# **A320 SLAT GRA ATA 27**

**RTW 2023**

**Liebherr - Aerospace**

## Solution:

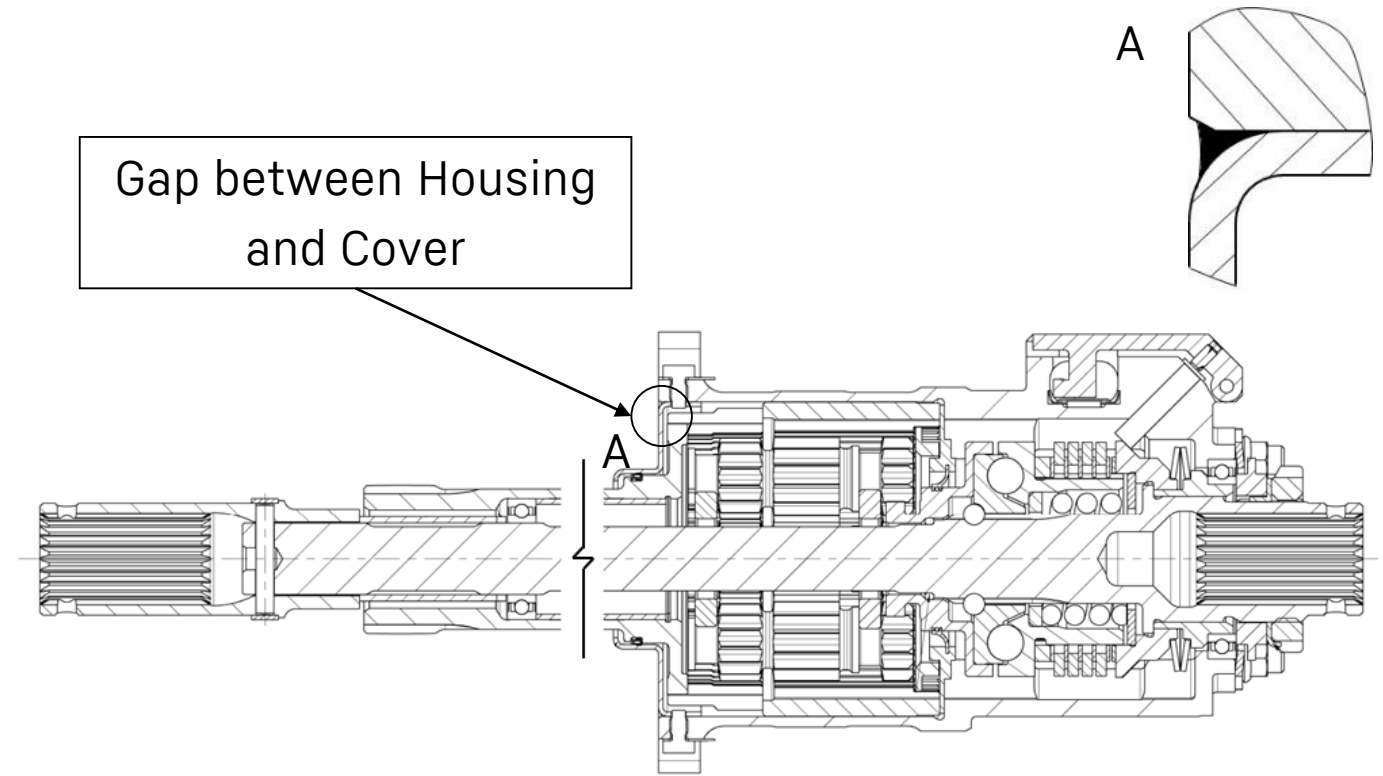
- Change the grease from AeroShell 33 back to Nyco GN22
- Sealing the gap between the Housing and the Cover.

PNR 830E0000-01: Planetary gear filled with lubricating grease NYCO GN22
